REQUEST FOR A SEALED SOURCE OR DEVICE EVALUATION

Re: NR-1081-S-101-S

AMMENDMENT and CORRECTION TO APPLICATION FOR REGISTRATION OF BRACHYTHERAPY SEED FOR MEDICAL USE

Construction of ProstaSeed I-125

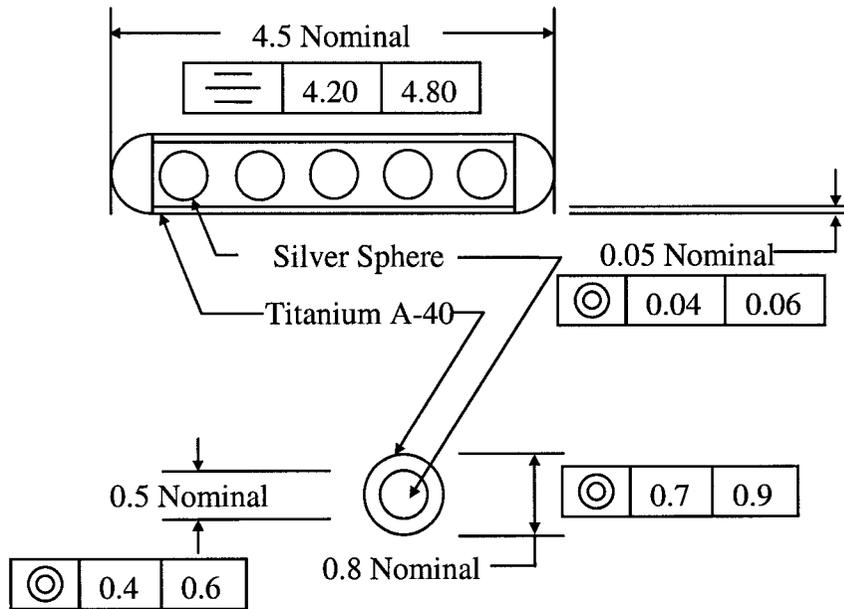
We are also clarifying the same statement for the I-125 seed. While all silver spheres used in the I-125 seed will remain radioactive, the seed may contain three – five spheres as stated in the Registration Certificate No. NR-1081-S-101-S dated December 1, 1999.

Both models contain **three to five** silver spheres. The Model I-125 SH contains a maximum activity of 150 mCi (5.55 GBq) and the Model I-125 SL contains a maximum activity of 1 mCi (37 MBq). The two models differ only in total radioactivity contained.

1. All dimensions in millimeters
2. Not drawn to scale
3. The seed may contain 3 to 5 silver spheres
4. All five silver spheres are radiolabeled with Iodine - 125

Construction of ProstaSeed Pd-103

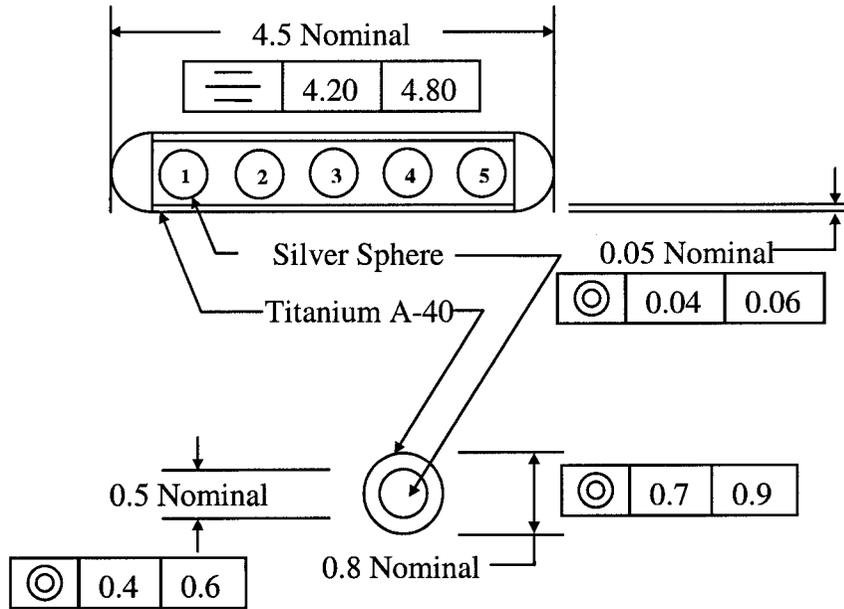
The July 29, 2001 letter states that "Both I-125 and Pd-103 models contain five silver spheres. All silver spheres are coated with radioactivity, i.e. we do not manufacture the sources with inert spheres for spacing purposes." Prior to the market launch of the Pd-103 seed it was determined that therapeutic effectiveness of the seed could be improved by reducing the number of radioactive spheres in the seed to two, and placing them in the sealed Titanium shell in a 1 HOT, 3 COLD, 1 HOT configuration. This change does not adversely impact the safety or effectiveness of the seed as described in this referenced Registration Certificate.

The Model Pd-103 SH and Pd-103 SL seeds contain palladium-103 on the solid silver spheres. Physical dimensions of both the silver spheres and titanium casting if the Model Pd-103 SH and Pd-103 SL seeds are identical to those of the iodine seeds as described above. **The titanium tubing is welded on one end, inverted, five spheres are added in a 1 hot – 3 cold – 1 hot configuration, and the remaining end is welded closed (See attachment 2).** The Model Pd-103 SH contains a maximum activity of 185 MBq (5 mCi) and the Model Pd-103 SL contains a maximum activity of 111 MBq (3.00 mCi). The two models differ only in total radioactivity contained.

1. All dimensions in millimeters
2. Not drawn to scale
3. The seed will contain 5 silver spheres
4. Silver spheres 1 and 5 are radiolabeled with Pd-103
5. Silver spheres 2, 3 and 4 are non-radiolabeled (inert) used for spacing
